CONSTRUCTION PLANS FOR

MILDRED STREET IMPROVEMENTS

As Built

GINN, INC.
Consulting Engineers Dallas, Texas
JUNE, 1990

| No. | Revision | By | Date |
|--|--------------|----------------------------|-----------------|
| Approved - HWG | Checked - GF | Scale - 1" = 20'H/1" = 5'V | Sheet M1 of 12 |

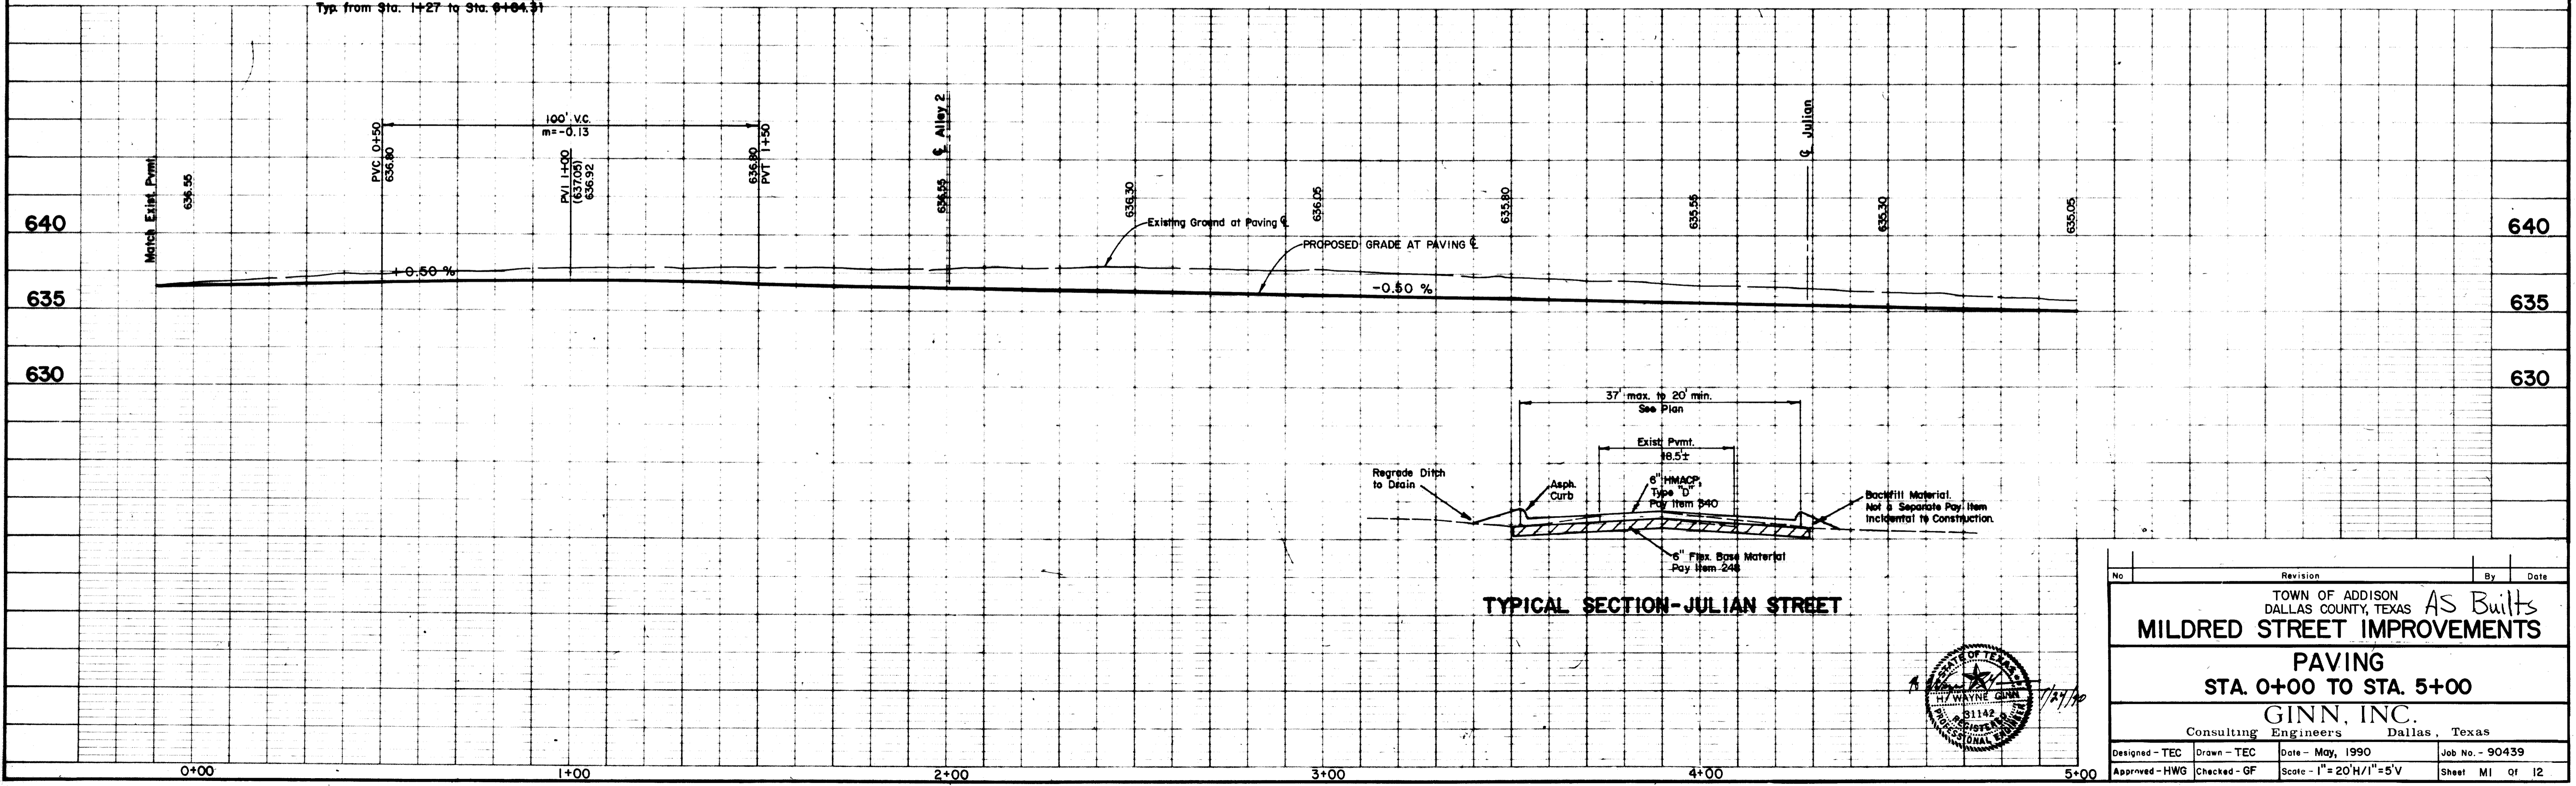
As per field change

Curb height varies from full 6" height to 0" at Walk.

Designed - GF Drawn - TEC Date - June, 1990 Job No. - 90443
Approved - HWG Checked - GF Scale - 1"=40' Sheet S2 of 10

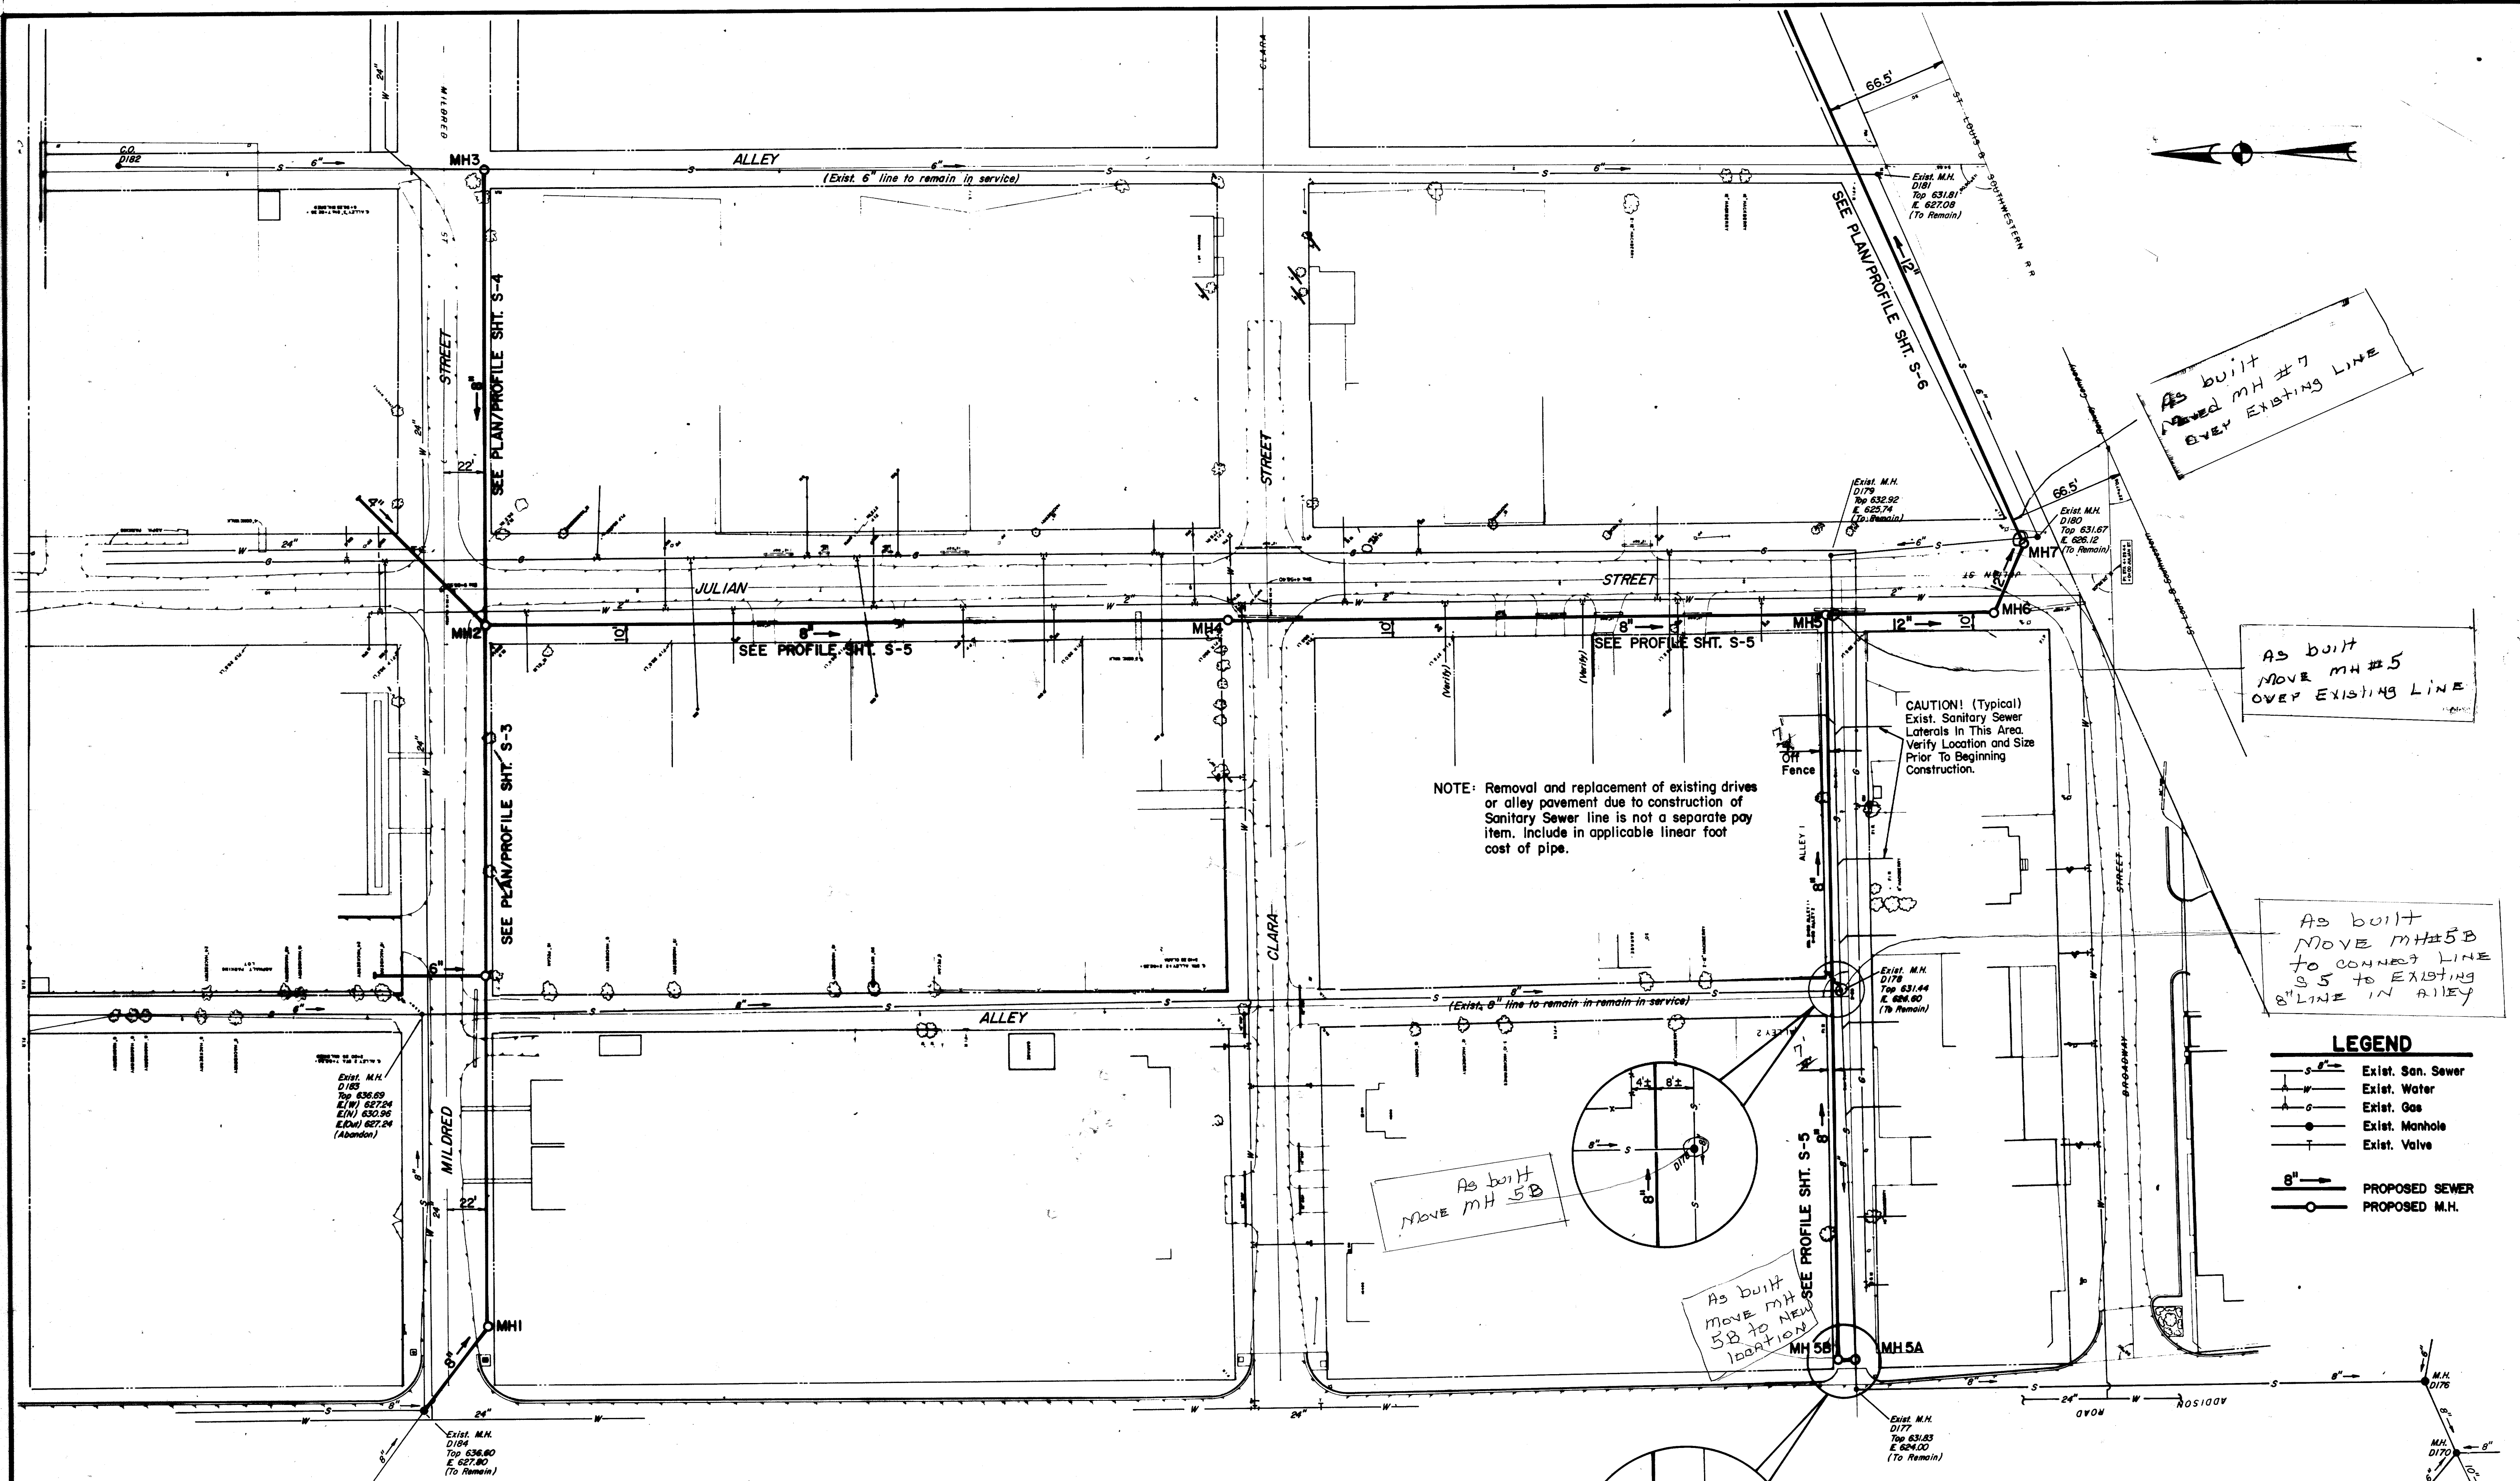
As built
MOVED MH #7
OVER EXISTING LINE

As built
MOVE MH #5
OVER EXISTING LINE

As built
MOVE MH#5B
TO CONNECT LINE
S-5 TO EXISTING
8" LINE IN ALLEY

As built
MOVE MH 5B

As built
MOVE MH
5B TO NEW
LOCATION

As built
MOVE MH 5B
TO NEW LOCATION
